SUNDRY NOTICES AND REPORTS ON WELLS

2. NAME OF OPERATOR
Merrion Oil & Gas Corporation

8. FARM OR LEASE NAME
Canyon Largo Unit

9. WELL NO.
128

WELL LOCATION AND ACRES DEDICATION PLAT

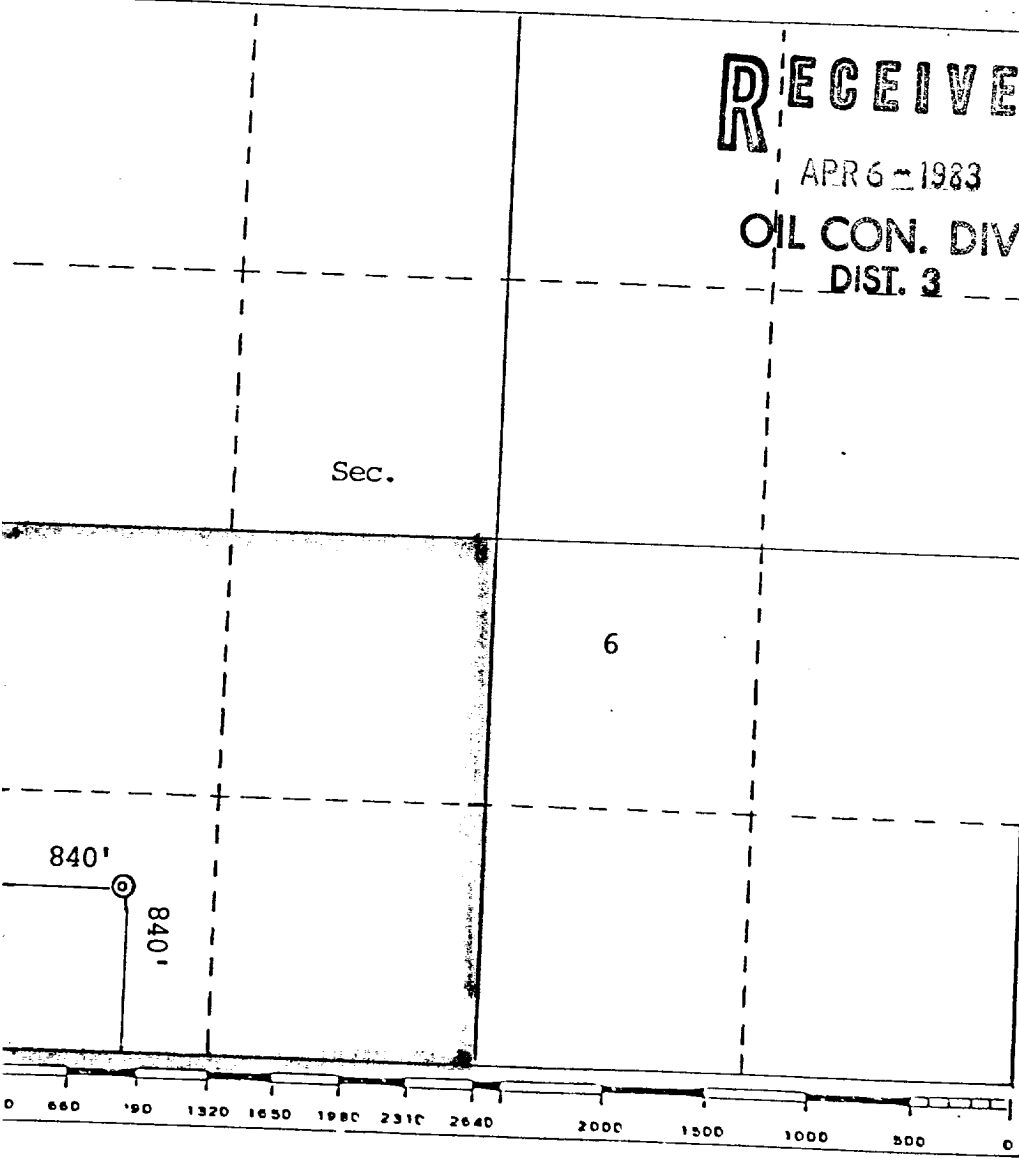
Attached is a plat indicating 160 dedicated acres instead of 80 acres.
